Volume II
of the
Final EIS/EIR for the
Van Ness Avenue BRT Project

Appendices I & J

Response to Comments

A-7e-60
continued

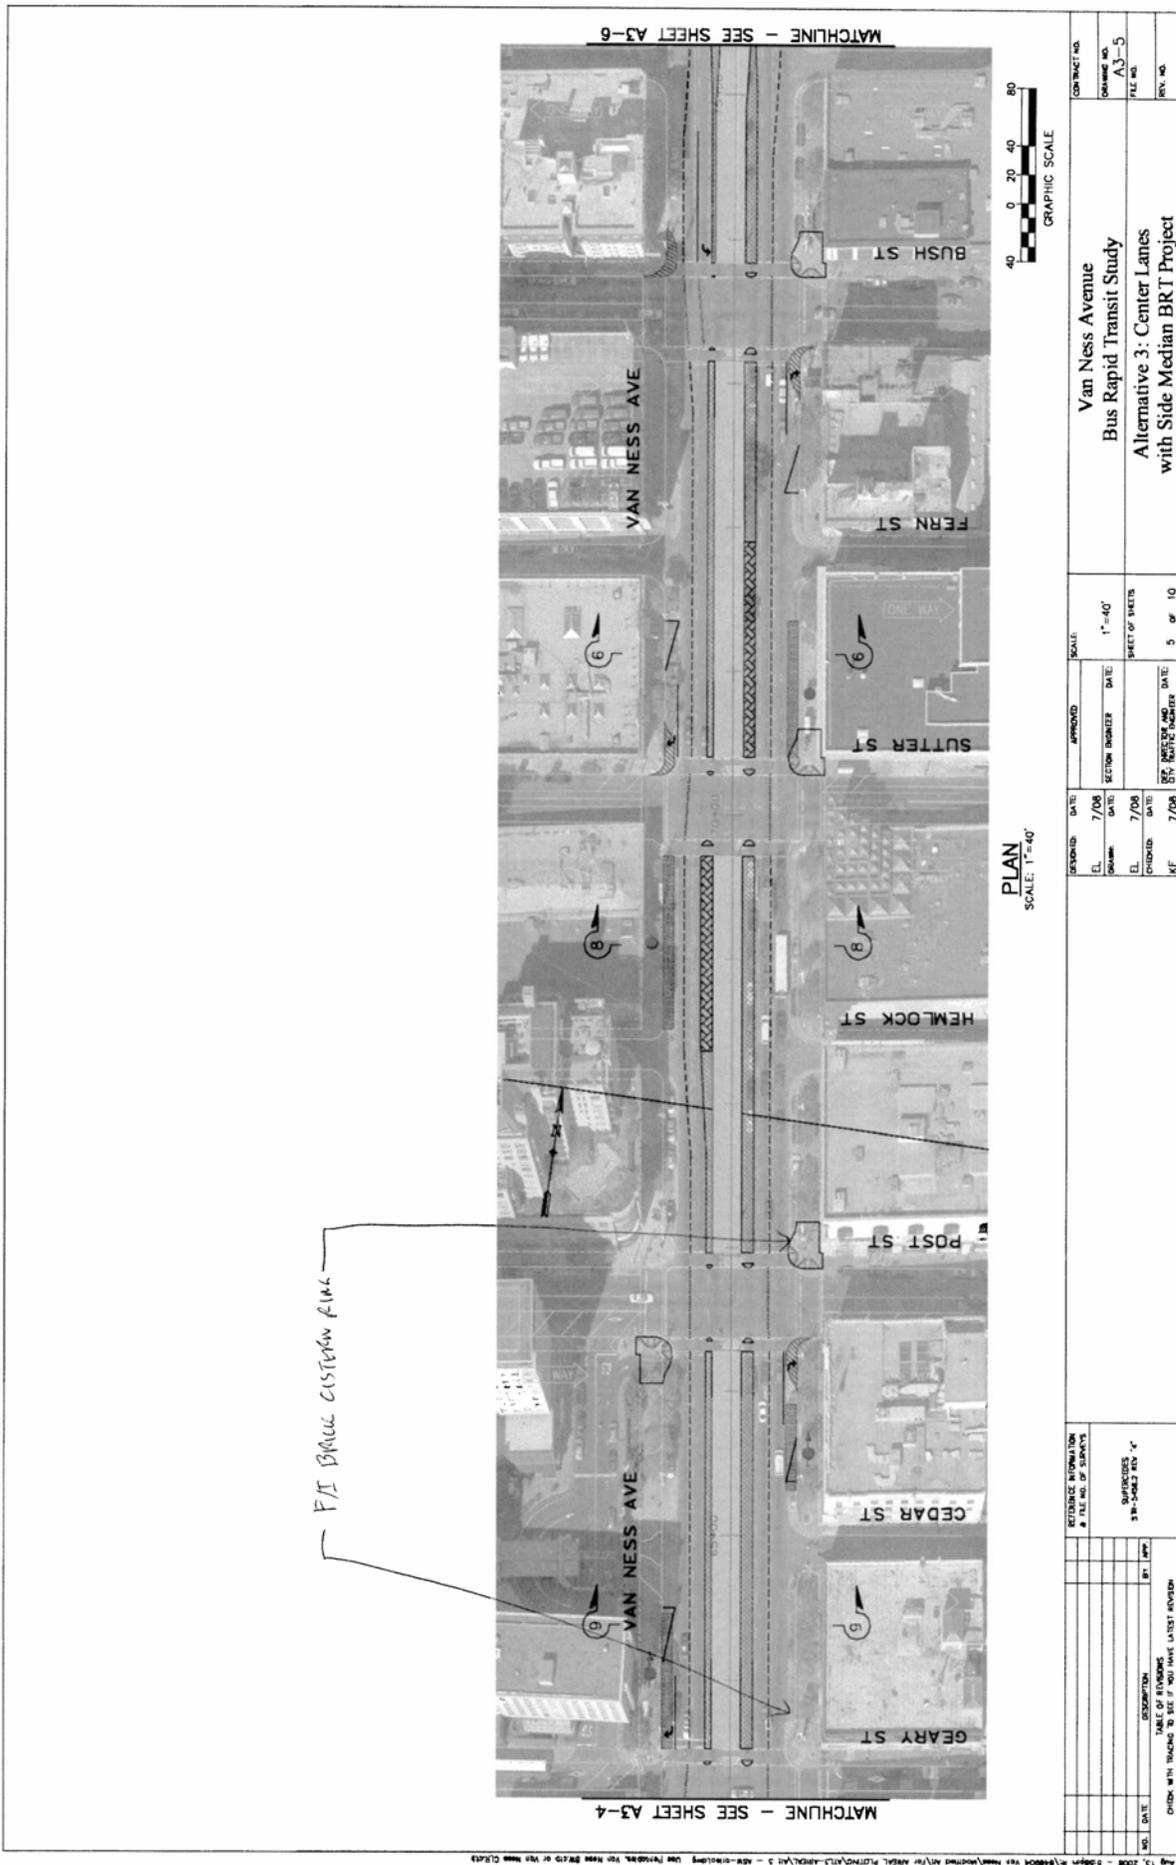
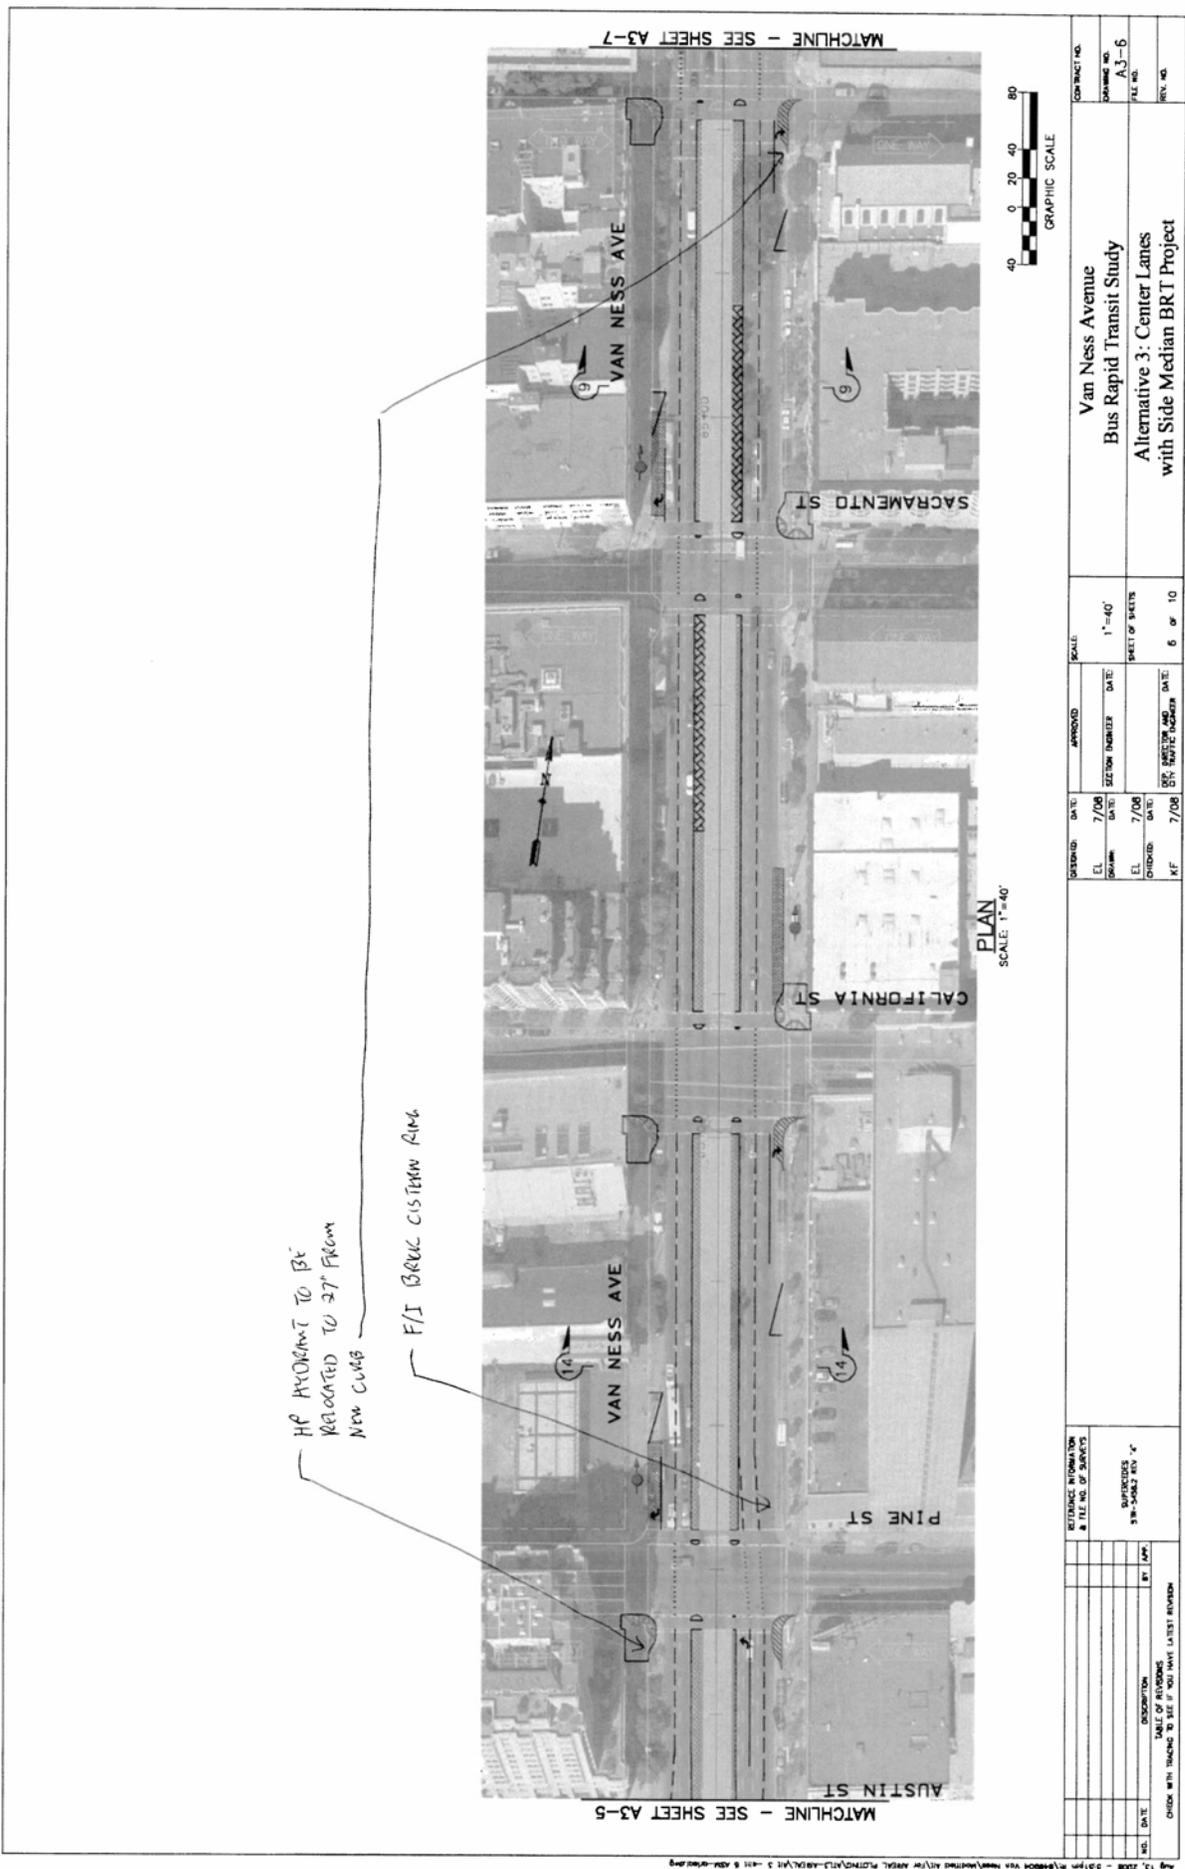
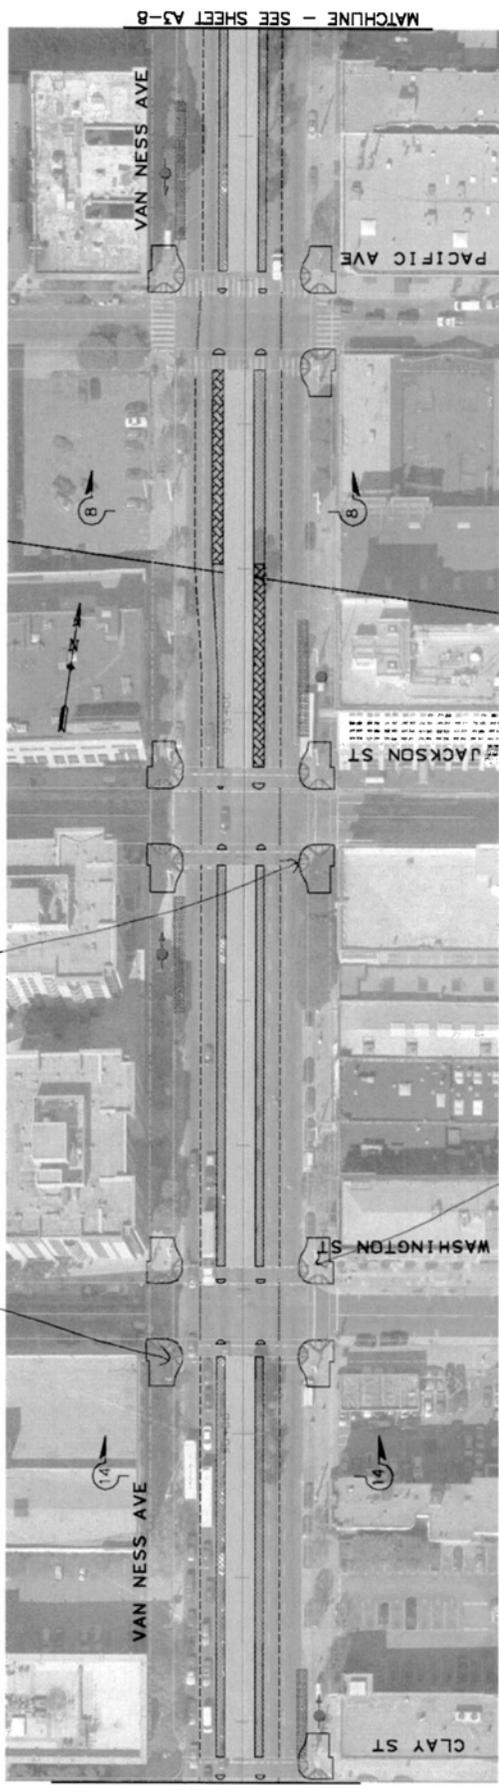
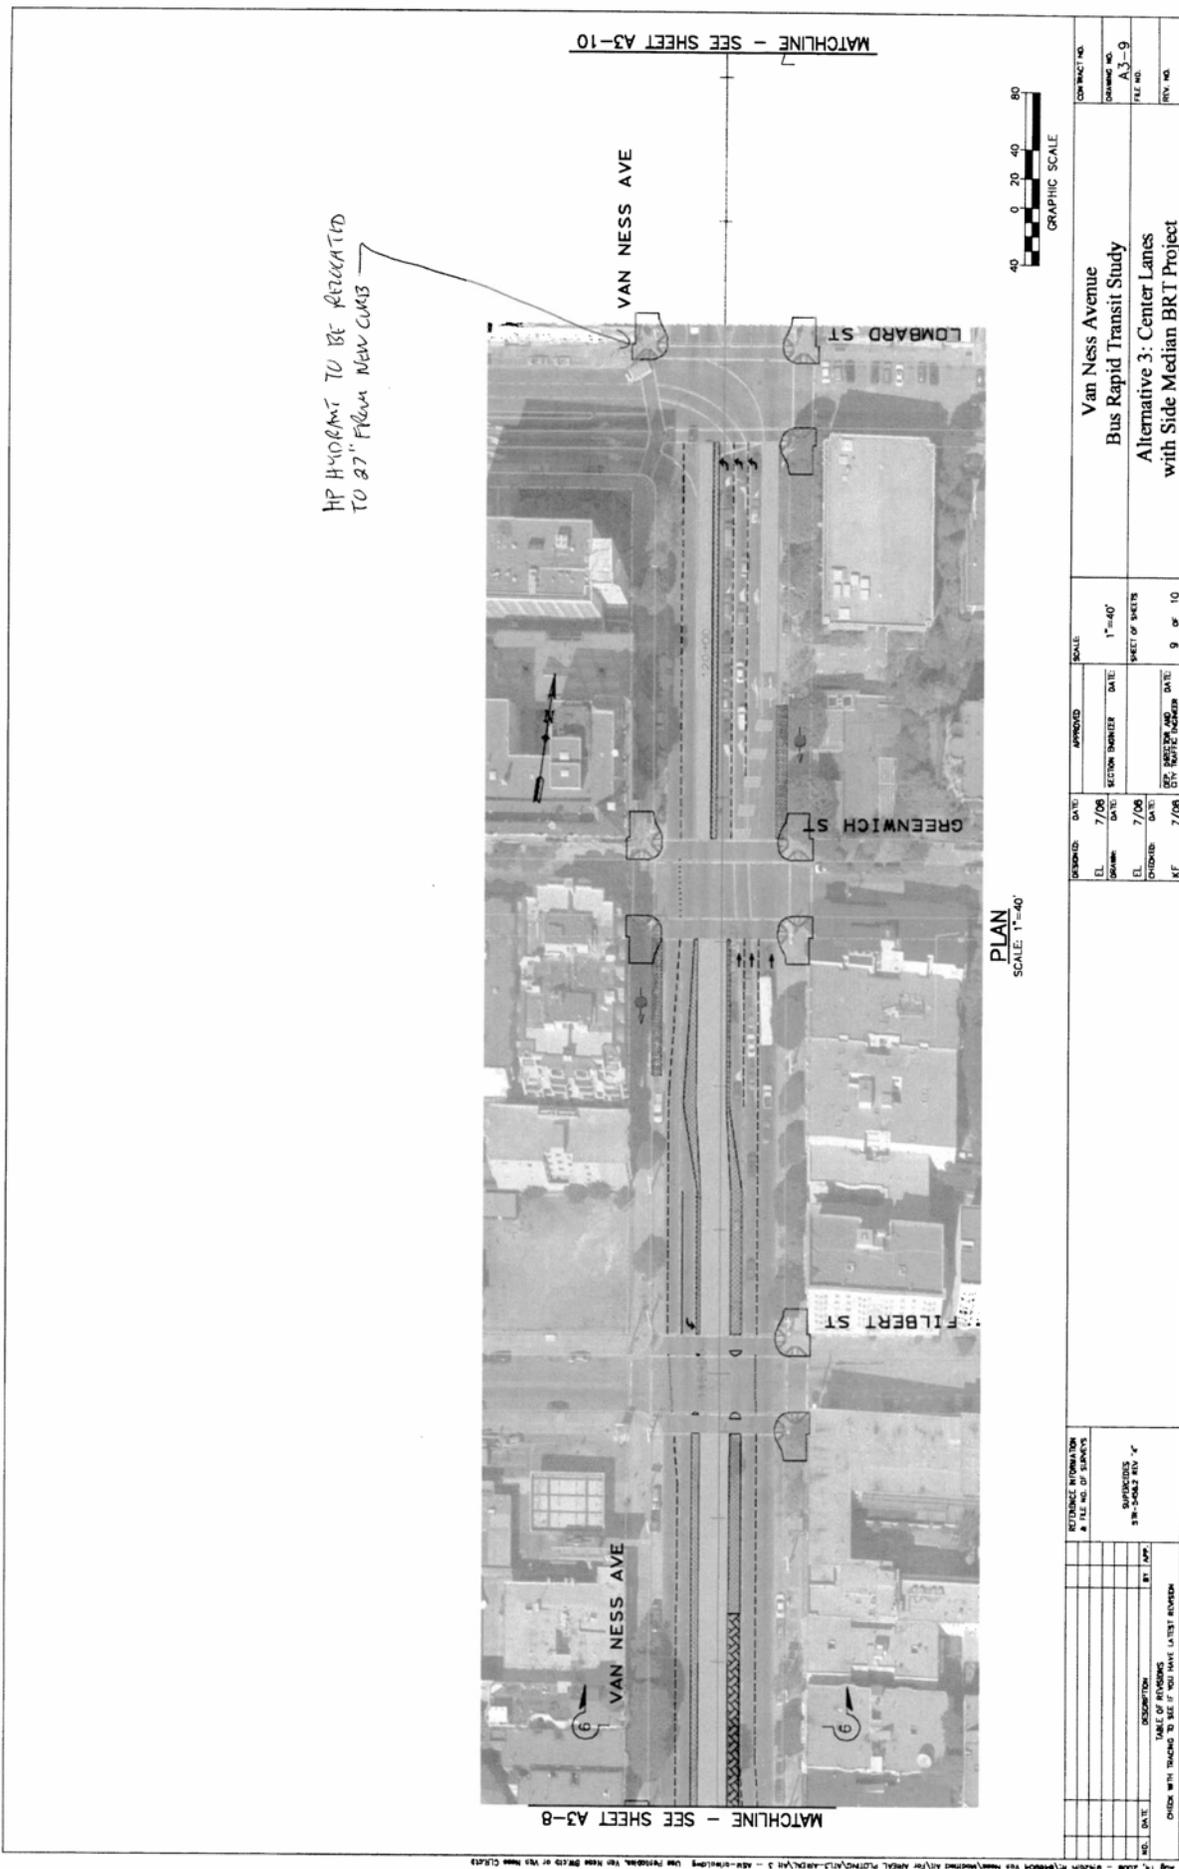
A-7e-60
continued

F/I BRICK CISTERN COVERS
RAISE CISTERN COVERS

HP HYDRA-MT TO BE
RELOCATED TO 37' FROM
NEW CURBS

F/S NEW CYCLIC CISTERNA RING
